COUNTY OF VENTURA PUBLIC WORKS AGENCY WATERSHED PROTECTION DISTRICT ZONE 2 "J" STREET DRAIN IMPROVEMENT ORMOND BEACH LAGOON TO DOWNSTREAM OF HUENEME ROAD IN THE CITY OF OXNARD

SAVE DATE: 5/21/13 DOKTORN K:\PC\PROJECTS\82322 J STREET DRAIN IMPROVEMENT\FINAL DESIGN\DESIGN DRAWINGS\100%ADDENDA\ADDENDUM NO. 1\JSD-01-GP.DWG

"J" STREET DRAIN IMPROVEMENT
ORMOND BEACH LAGOON TO
DOWNSTREAM OF HUENEME ROAD
GENERAL PLAN

SHEET 7C	OF 31
DRAWING NO. Y-2-3711C

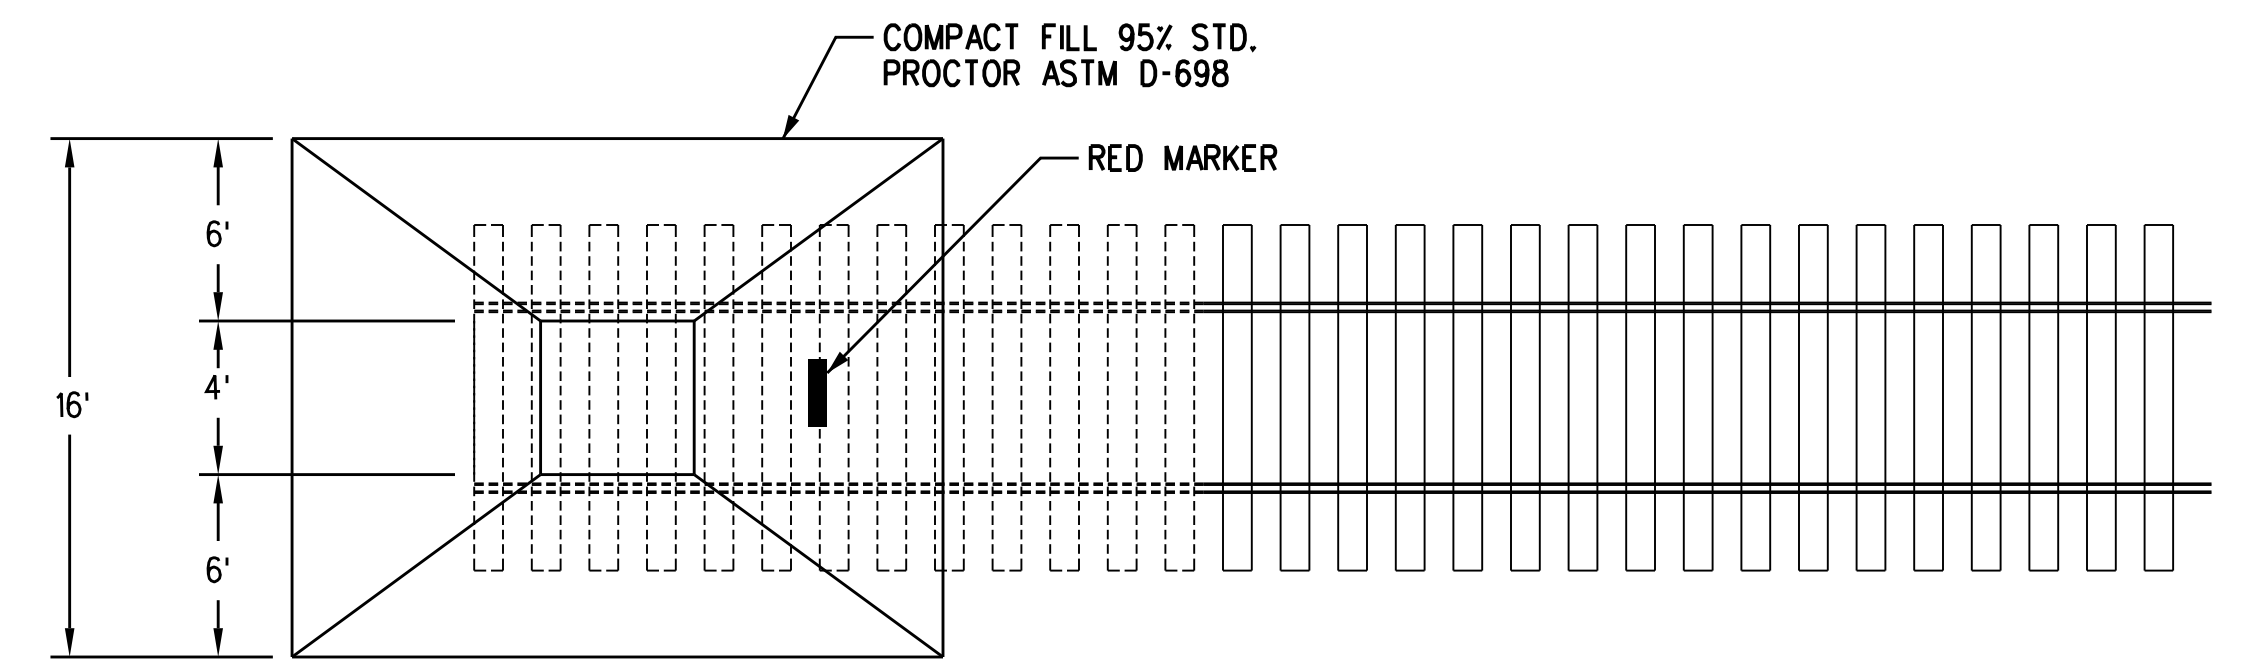
REVISION	DESCRIPTION	APP.	DATE
1	REVISE DETAILS AND CROSS SECTIONS	EML	06/21/13

SHEET 10
OF 31
DRAWING NO.
Y-2-3714

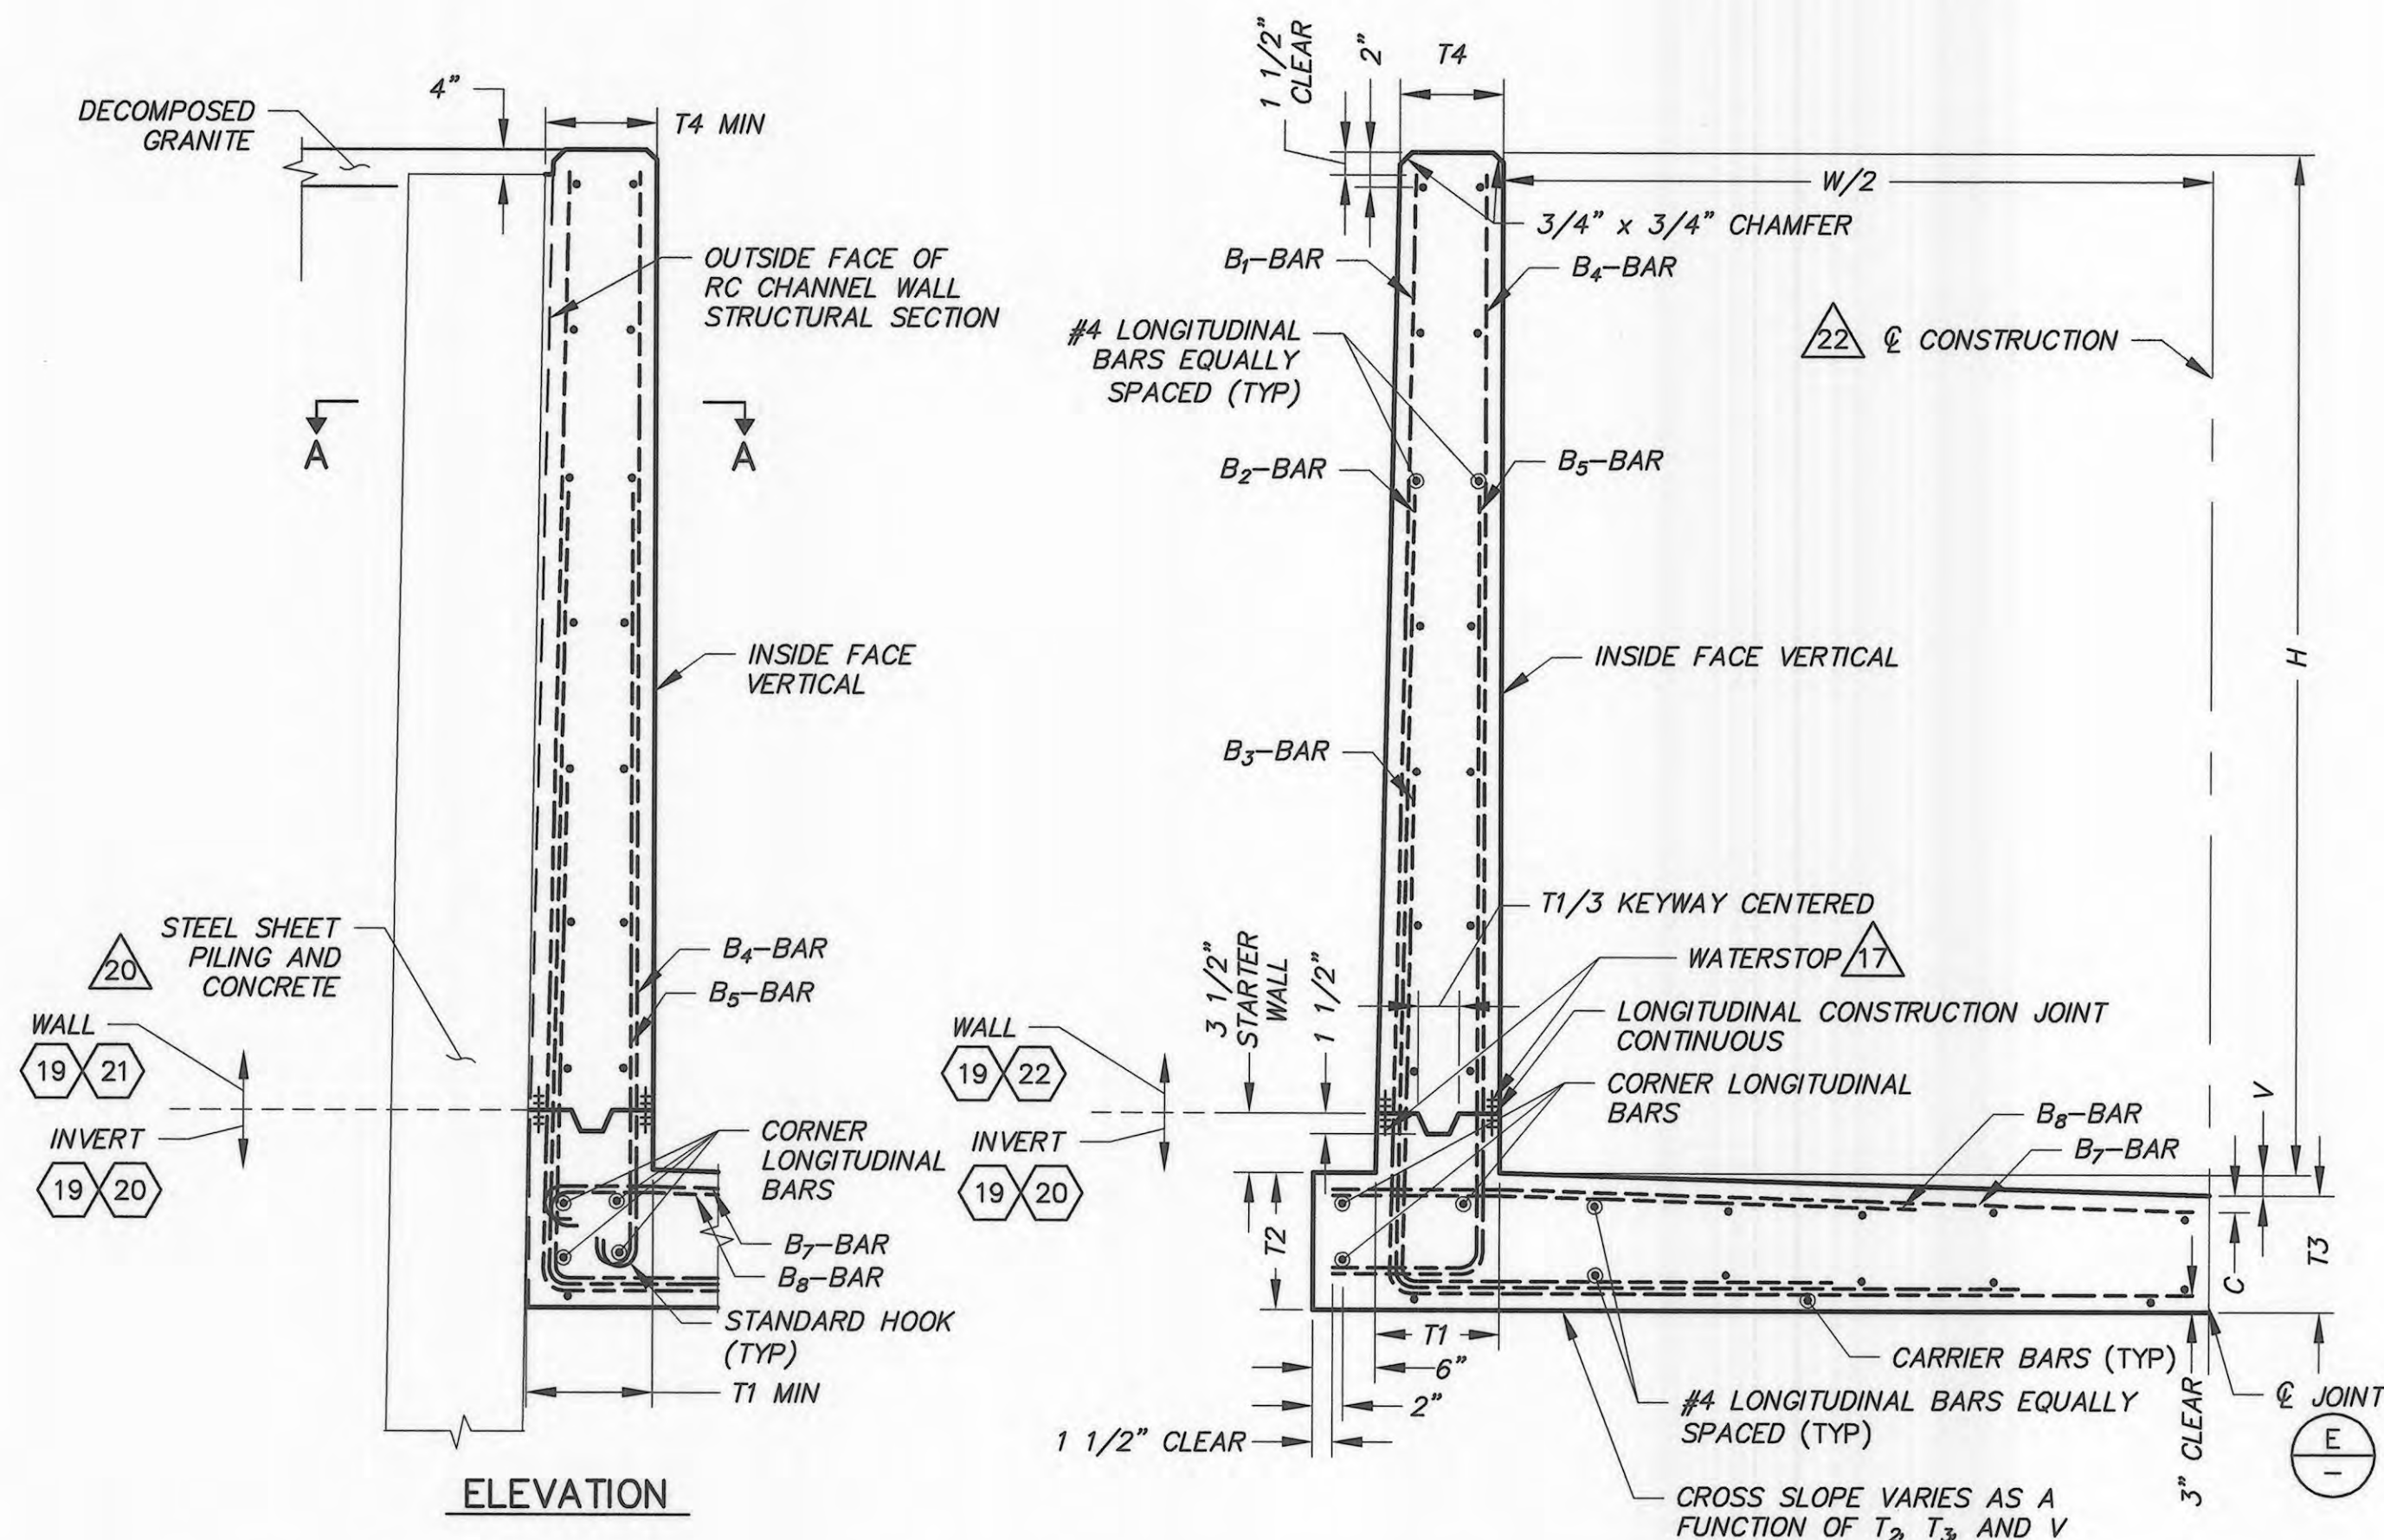
REVISION	DESCRIPTION	APP.	DATE
D			
C			
B	ADDED BACKING MATERIAL		
A	ADDED CHANNEL SECTION 7

SHEET 14
OF 31
DRAWING NO.
Y-2-3718

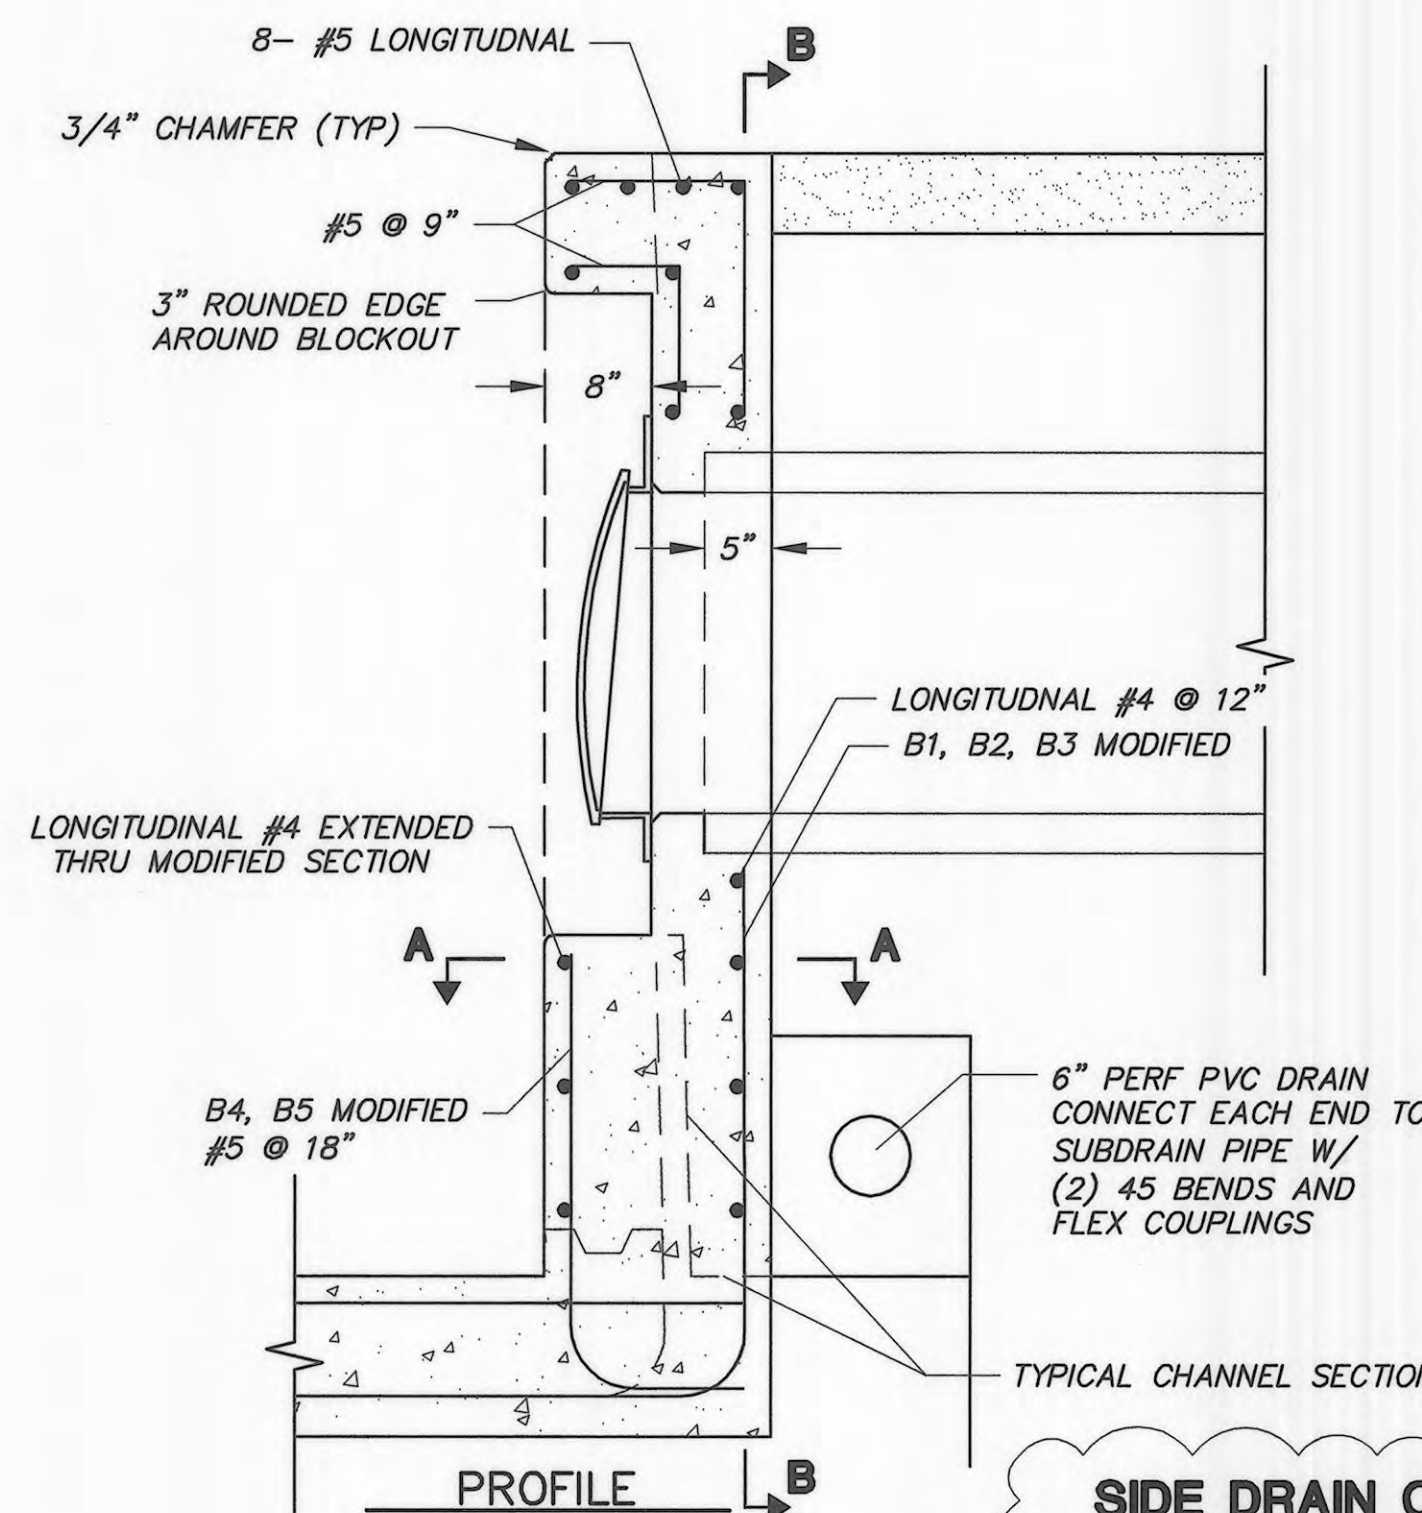
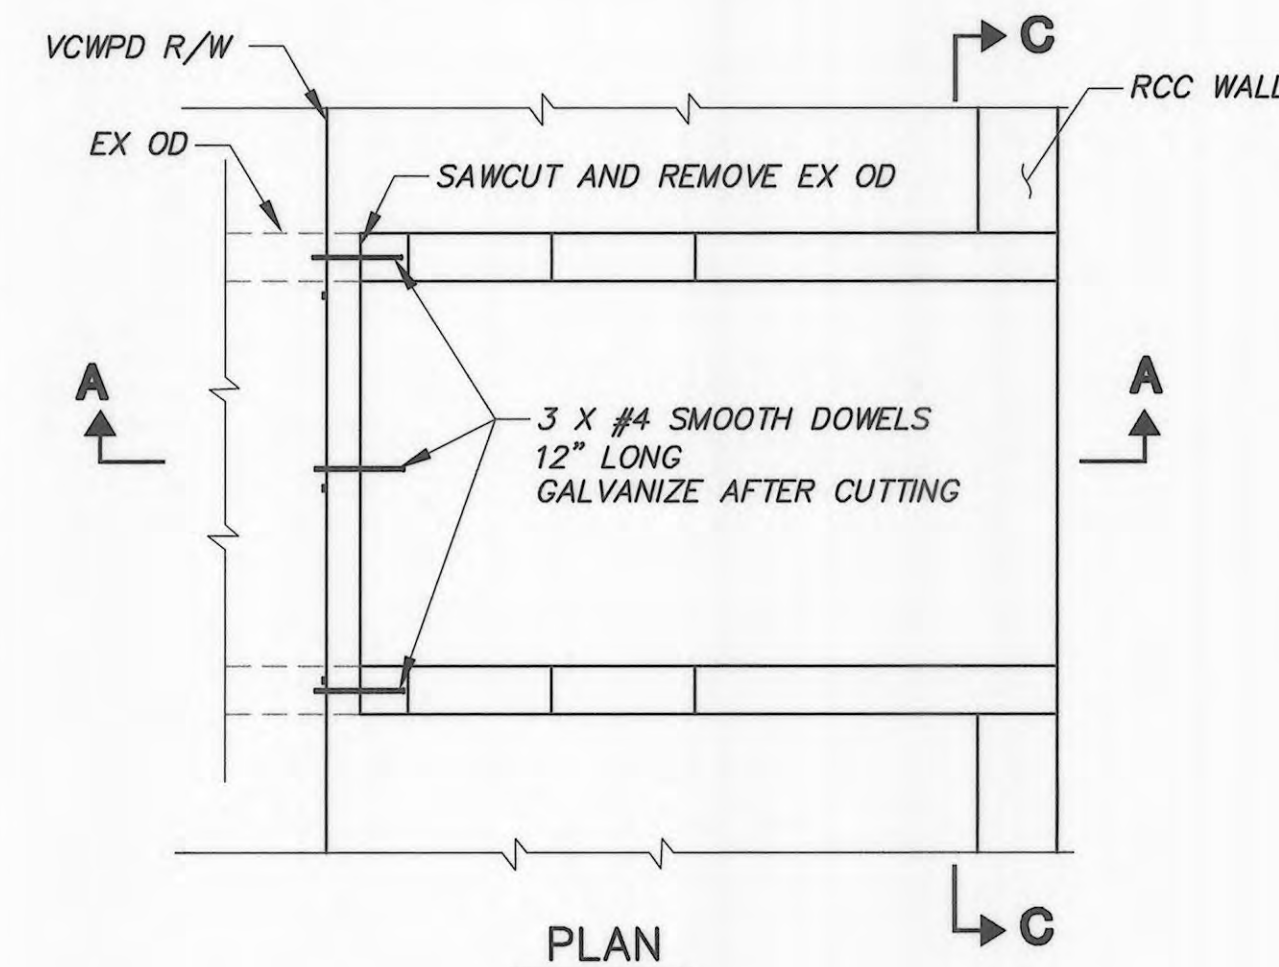
REVISION	DESCRIPTION	APP.	DATE
D			
C	REVISED NOTE 8		
B	REVISED TYPE C SIDE DRAIN CONNECTION		
A
